746-748 CONGRESS STREET

AP - 748 Congress St.

AP 748 Congress Street-1
(Installation of bake
oven)

Subject: Amendment #1 to permit 49/224
covering alterations not included in
original permit at 748 Congress Street

East Side
Metal Window with glass
748 Congress St. Clarke's Bakery

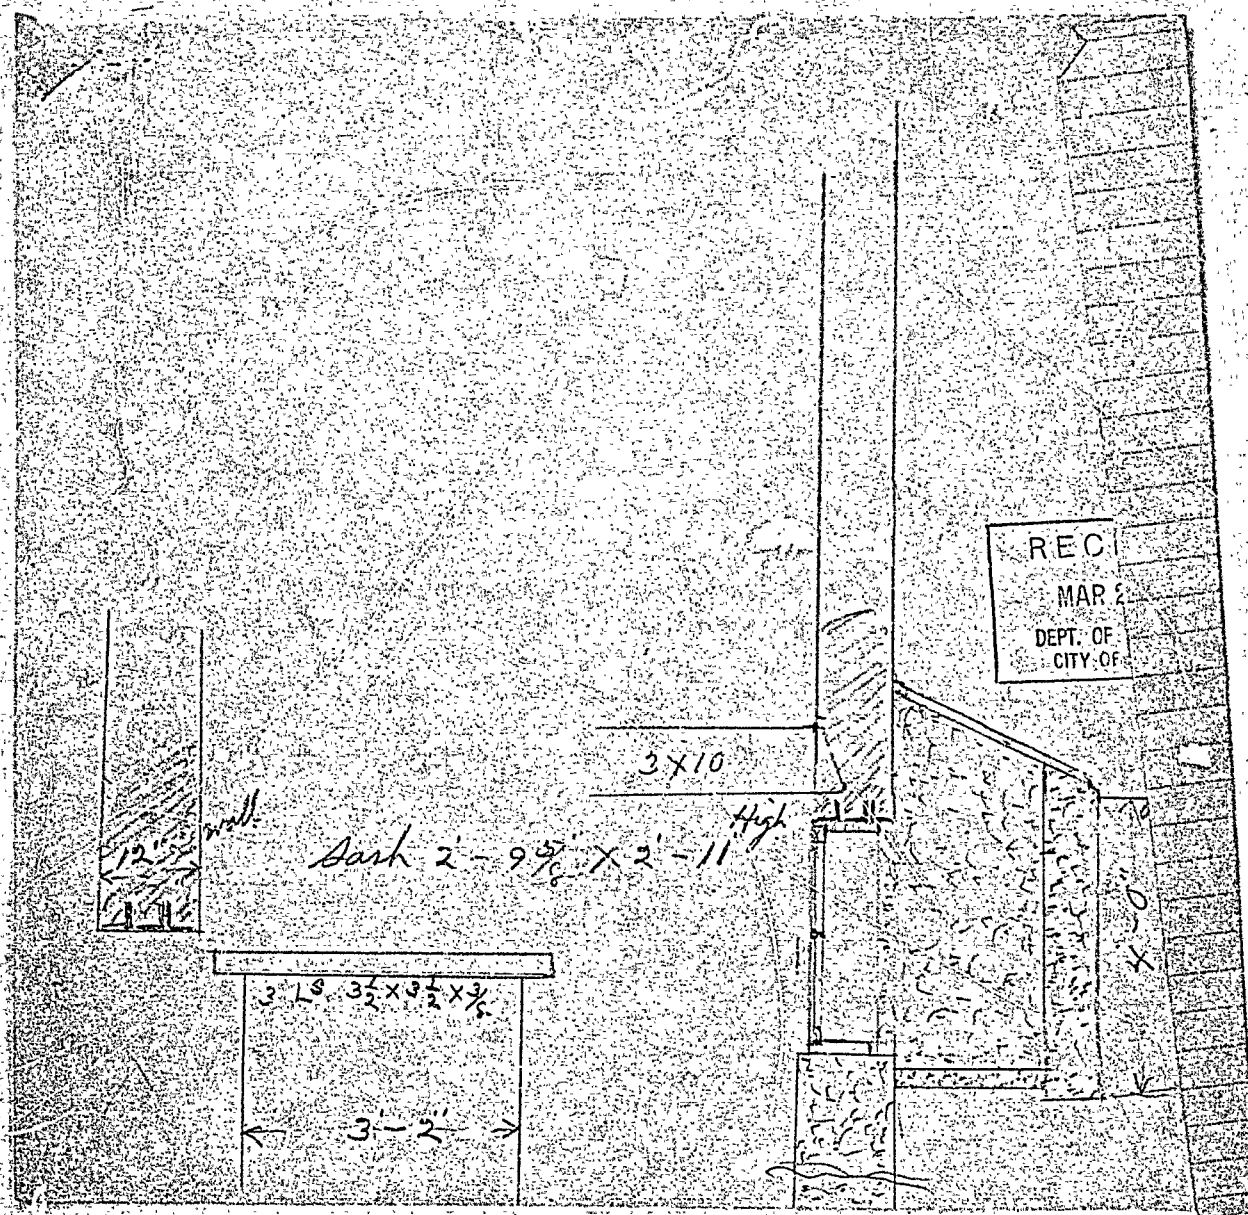
1. The window in the new arcway on the westerly side
of the building is required to be metal sash and wire glass as
well as that to be provided in the easterly wall of the build-
ing.

Ward 7 Permit No. 36/735
Location 748 Congress St.
Owner Robert G. Elliott
Date of permit 6/11/36.
Sign Contractor

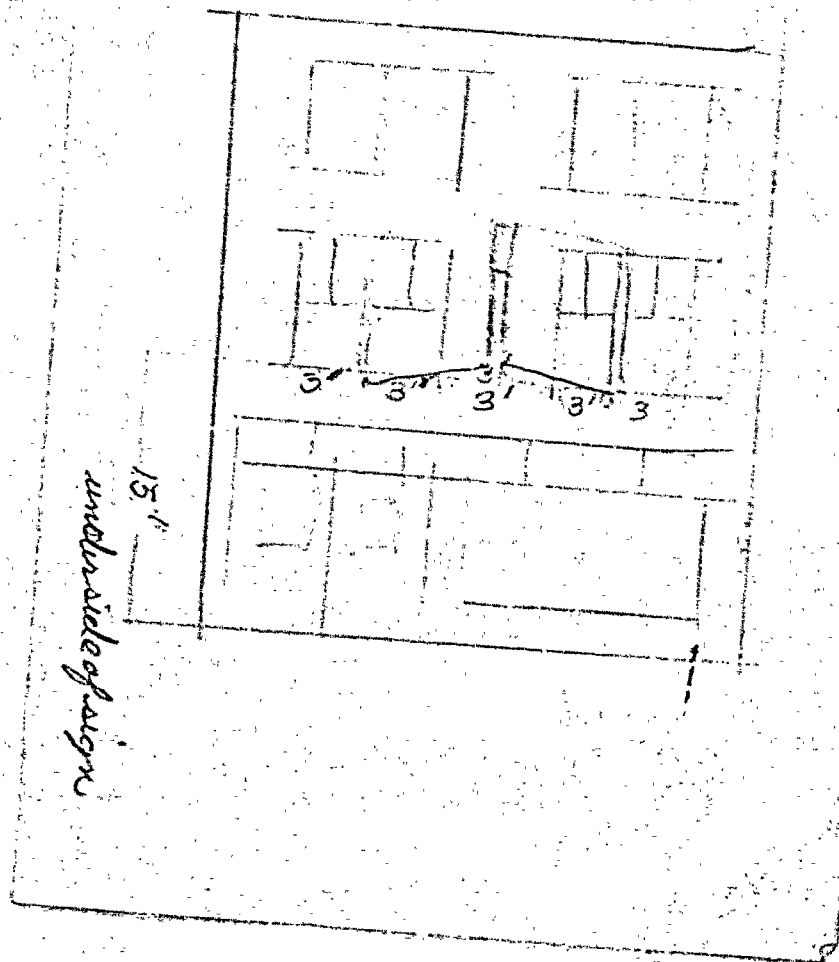
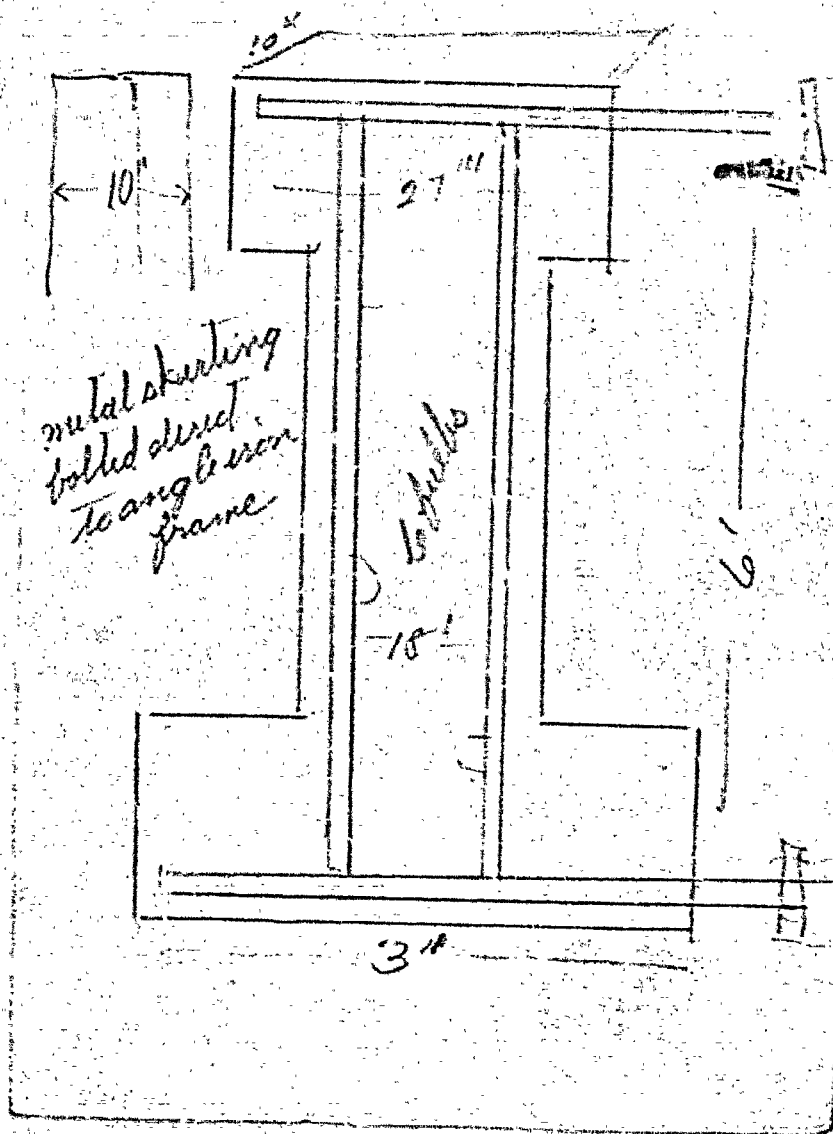
St. John
6/22/36. Sign is as per plan
except 30" wide and being
1 1/2" angles. Bottom
angle to be replaced, new
nuts and bolts to be
side and angle. All new
painted. Mr. Elliott
agrees to this. O.D.
Elev. 100
Sign
Sign file plan made
Distance above sidewalk - 14" 10"
6/22/36. I talked with Mr.
Reberts of the Genl.
Elec. & Mech. Corp. relative
to the distance of the
sign above the sidewalk.
Due to the fact that it
is unlikely that a
will be hung
in view of this, at
for the present.

told to me would pass
up the 2" that it is
short of the required
distance unless it is
questioned. O.D.
